ACP-2021-12

SPACEPORT 1 AIRSPACE
DESIGNS & DESIGN
PRINCIPLES EVALUATION
VERSION 2

16 March 2023

Figure 3: SOLLAS traffic patterns (in green) plus 1NM radius circle suggested manoeuvring area. (Source: Highlands & Islands Strut of the Light Aviation Association (LAA))

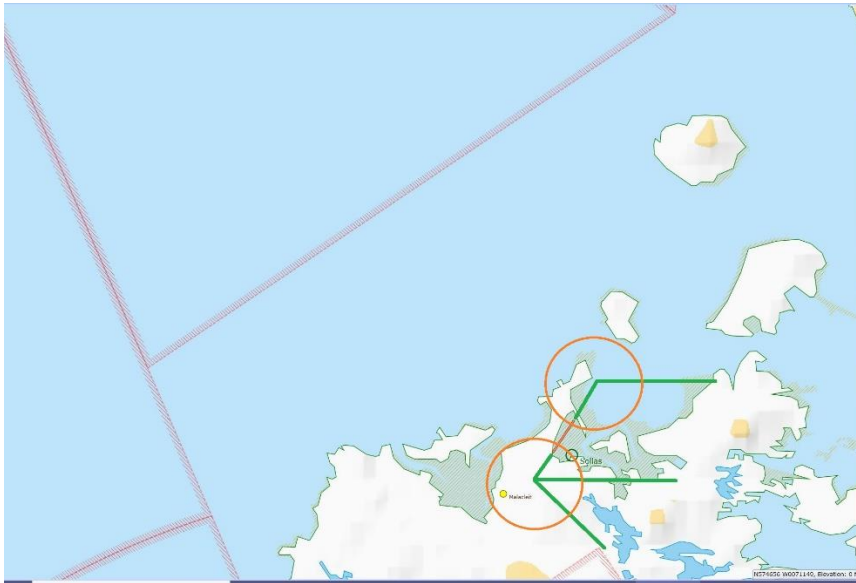
I have attached two diagrams. In the first I show the approach patterns in each direction to the beach at Sollas, and on it I have marked one nautical mile radius around the turning point to finals which reflect a degree of uncertainty of position according to wind conditions, etc. On the second I have marked the effect of these "variability" circles were you to accept a "dog-leg" in your TDA zone as drawn. An altered TDA boundary such as this would seem to eliminate the conflict with Sollas Beach without squeezing the TDA area too much, and I would welcome your comment on our suggestion.

However, it was documented during the TDA proposal development that this design had the potential to impact on the beach landing strip at Sollas. Following the concerns of Sollas stakeholders and provision of traffic patterns to the beach site (see Figure 3), and subsequent delay of the TDA, further in-depth safety analysis was conducted, the results of which demonstrated the eastern boundary of the fillet could be safely re-profiled so as not to affect the landing site at Sollas¹¹. The original airspace fillet design is therefore discounted as an option in favour of the new proposed design that is shown at Figure 4.

Figure 4: New proposed re-profiled small 'fillet' of segregated airspace around the SP-1 launch site

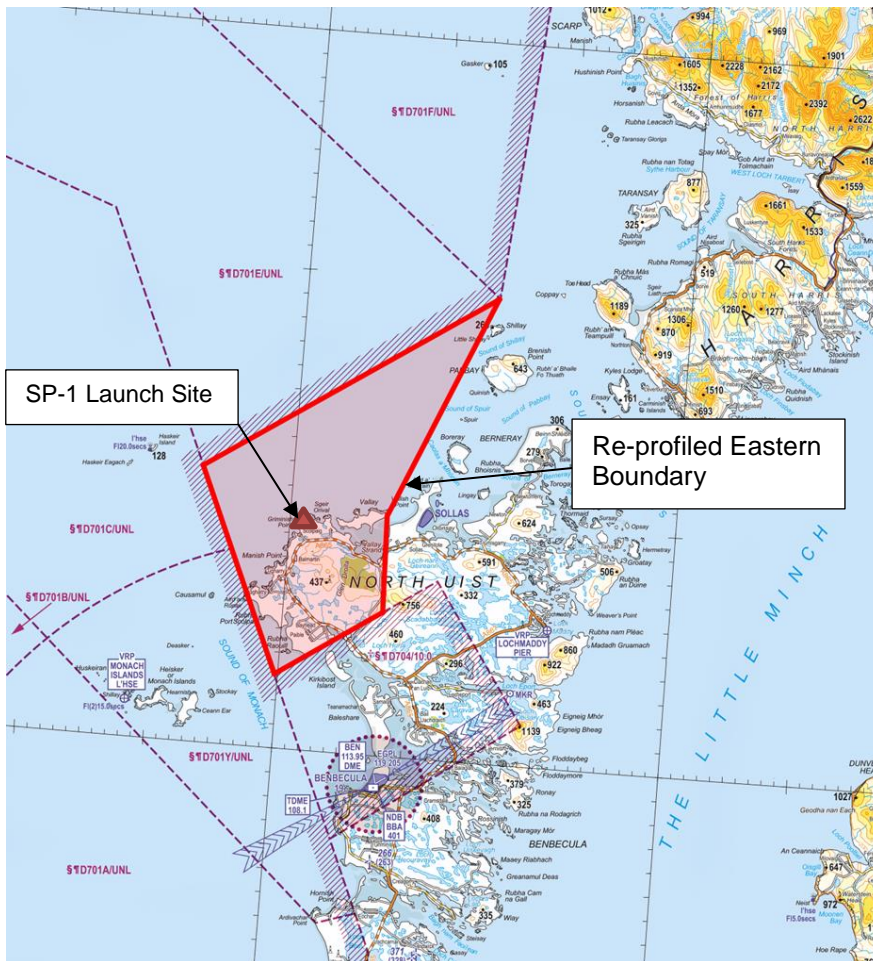
- Notes the revised boundary of the DA element around the Spaceport 1 launch site itself (Figure 4) following Stakeholder input, and asks whether (in the interests of minimising the amount of airspace affected) the NE corner of this element could be moved further to the SW, reducing the size of the “dog leg” on the E side of this element.

2. NATS notes the revised boundary of the DA element around the Spaceport 1 launch site itself (Figure 4) following Stakeholder input, and asks whether (in the interests of minimising the amount of airspace affected) the North Eastern corner of this element could be moved further to the South West, reducing the size of the "dog leg" on the Eastern side of this element.

Sponsor Reply – Option 4 will be considered in the options appraisal at Step 2B as it is accepted several DPs make specific reference to use of D701 and this should not exclude the radical option of a wholly new airspace design (this is captured in the DP evaluation for Option 4). Furthermore, Option 4 has been modified to provide a more symmetrical airspace design (see *Figure 16*). Option 5 has similarly been modified with a view of reducing the impact on OEPs and to simplify the design (see *Figure 17*). The NE corner of the airspace ‘fillet’ cannot be reduced further as this would prohibit launches to the north. All other points are noted and will be addressed as the ACP process progresses.

Figure 16: Option 4 revised potential design with D701 overlay

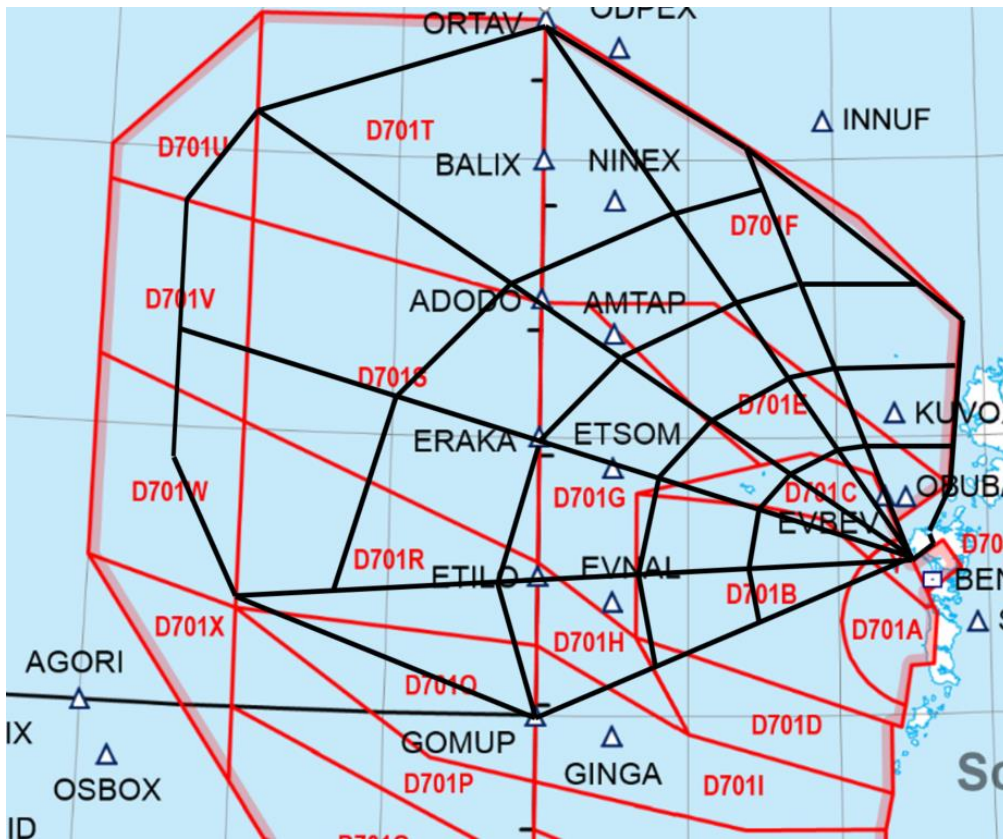
Following stakeholder feedback (NATS) it was decided to redesign Option 4 to better reflect a symmetrical design aligned on the SP-1 site as suggested. What such a design might look like is presented at *Figure 16*.

Figure 17: Two potential modifications to D701 Option 5

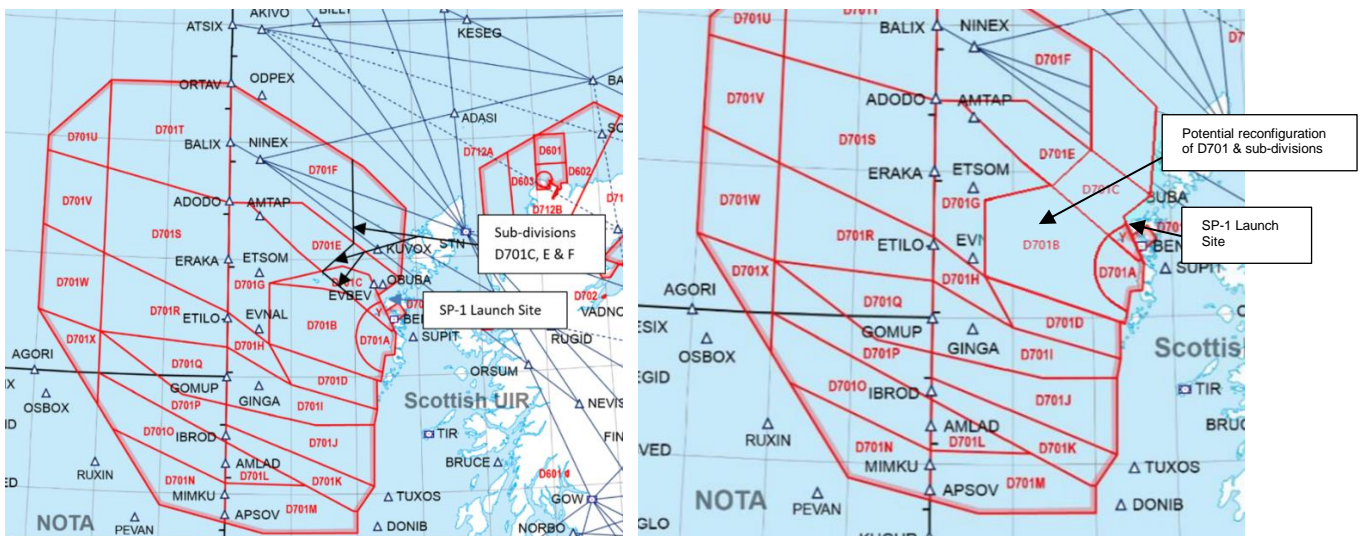
Following feedback from both NATS and MOD, the potential sub-divisions of D701 presented in Option 5 have also been revised and are shown as two different possibilities in Figure 17. Both possibilities are aimed at reducing the overall airspace necessary for some launches while simplifying the design without adversely impacting, to any greater extent, on OEPs. It is recognised that further work will be required to refine/sub-divide D701 if this option is taken forward as the preferred option.

Sponsor Reply – Fully support the MOD feedback and work is ongoing to formalise use of D701 under the LTPA. The sub-divisions of D701 can be further simplified to reduce the number of additional areas and still meet the SP-1 requirements and that of the Hebrides Range. The UK SpOC will be afforded the necessary information to undertake their duties as this is a requirement placed on the rocket provider as part of their approvals/permissions process.
